Technical Note

Project: Earl Shilton, Leicestershire

Subject: Response to Leicestershire County Council's Comments

Client:	Vistry		
Project No:	09924	Version:	A
Document Ref:	09924-TN-02	Author:	Lewis Griffiths
Date:	25/06/2026	Approved:	Richard Ellam

File name C:\PJA\PHIL JONES ASSOCIATES\SHAREDDATA - 09924 - EAST SHILTON\3. TECHNICAL\3.1 DRAWINGS\09924.GA.01 LG REV B.DWG, printed on 12/06/2026 16:39:21, by Lewis Griffiths

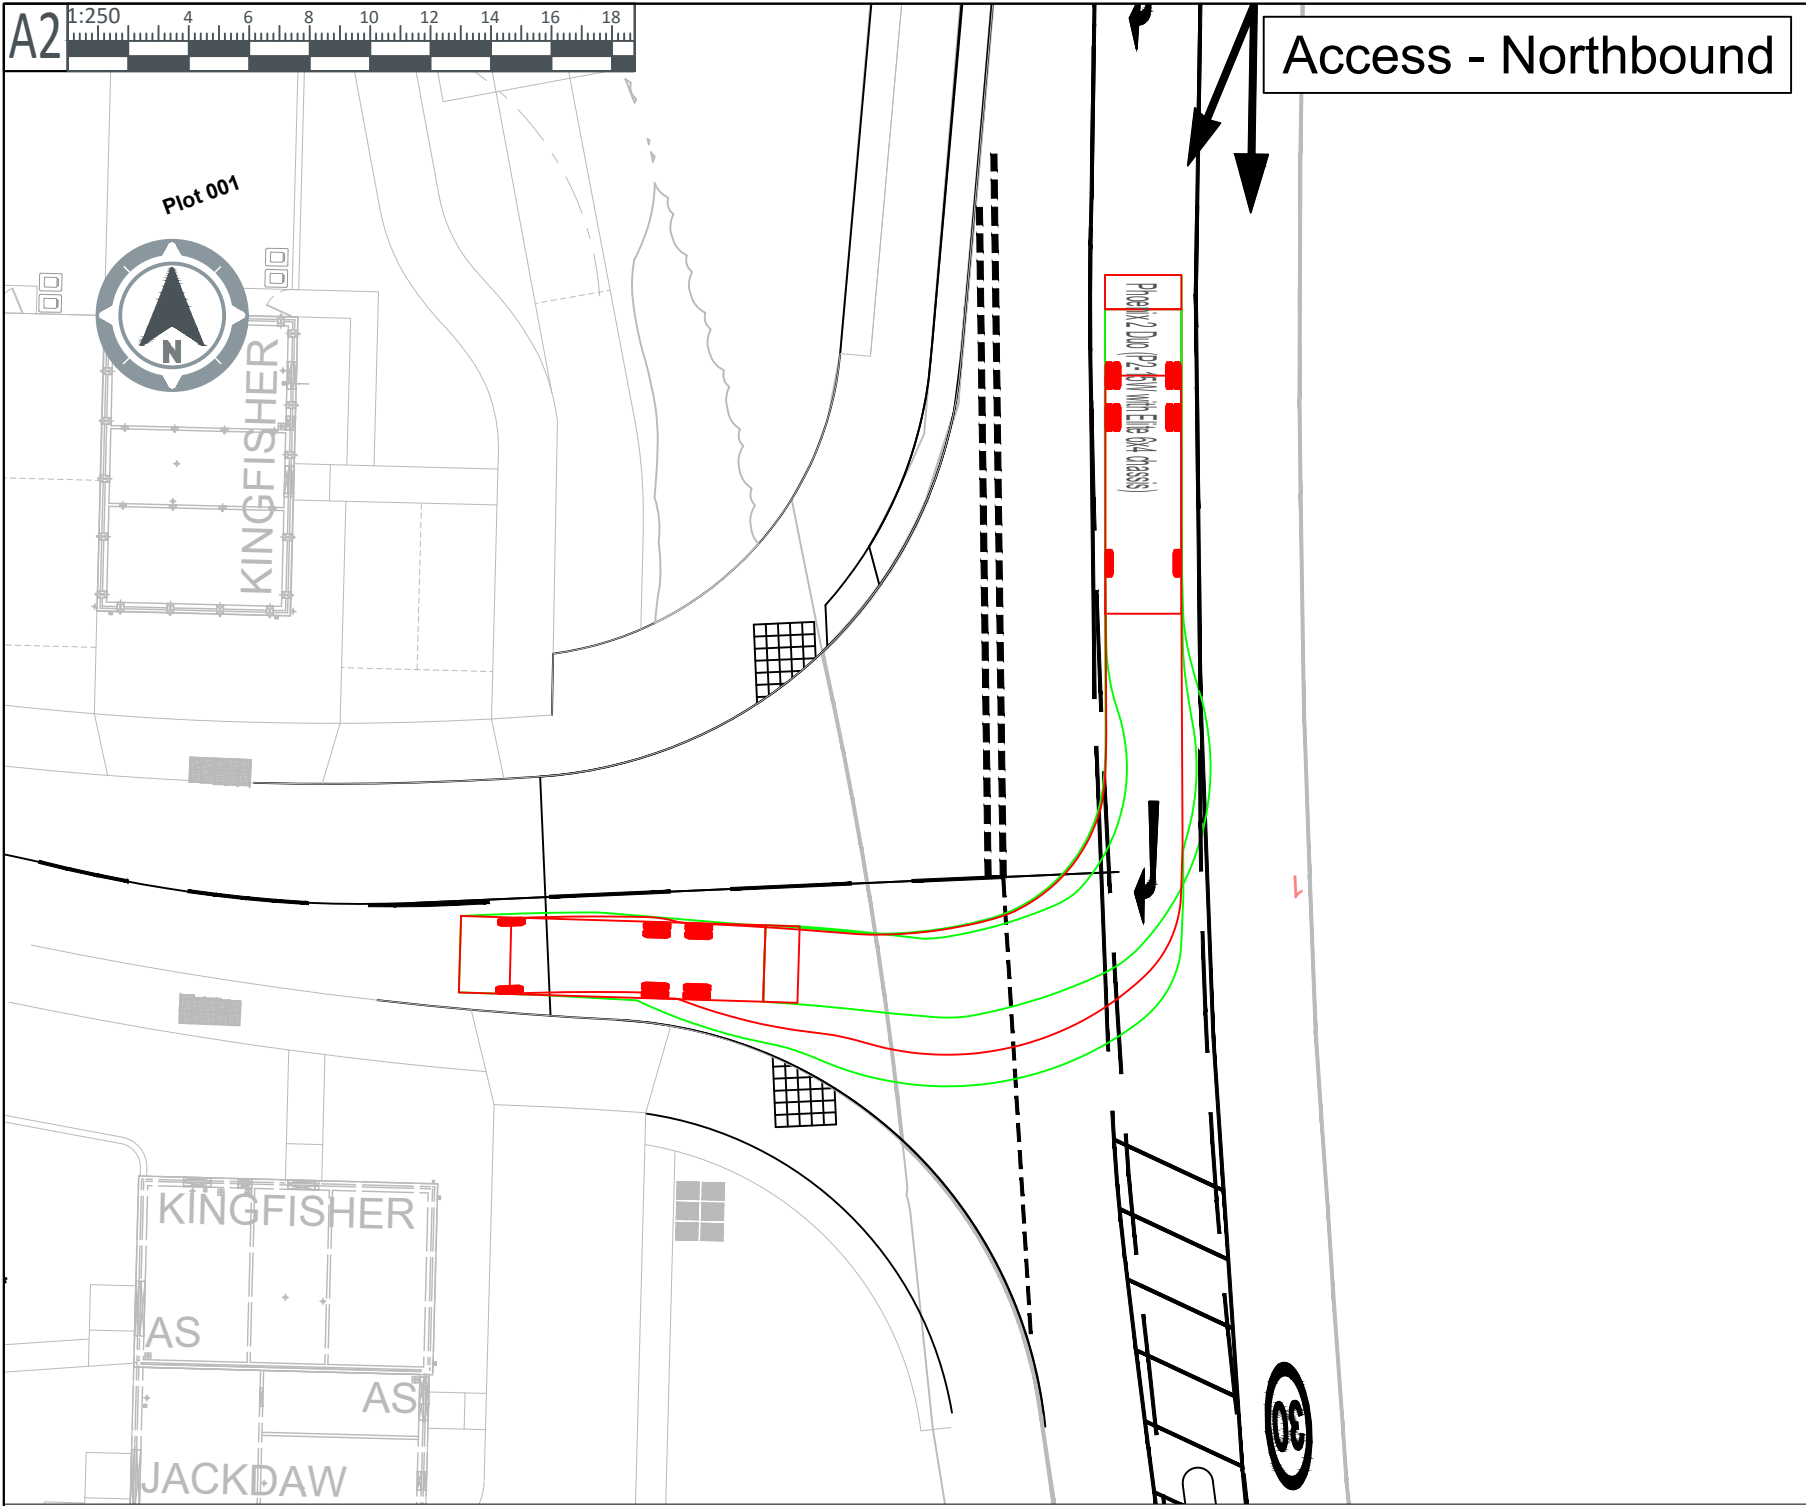
"No swept path analysis has been shown, which further adds to the concerns over the speed limit extension proposed above."

3.1.4 Swept path analysis has now been undertaken at the proposed access along with the right turn pocket provision. The swept path analysis was undertaken using an 11.2m refuse vehicle to provide a robust assessment as it is unlikely that a vehicle larger will require entry to the site. The swept path analysis is illustrated within drawing 09924.GA.02 provided in **Appendix E**.
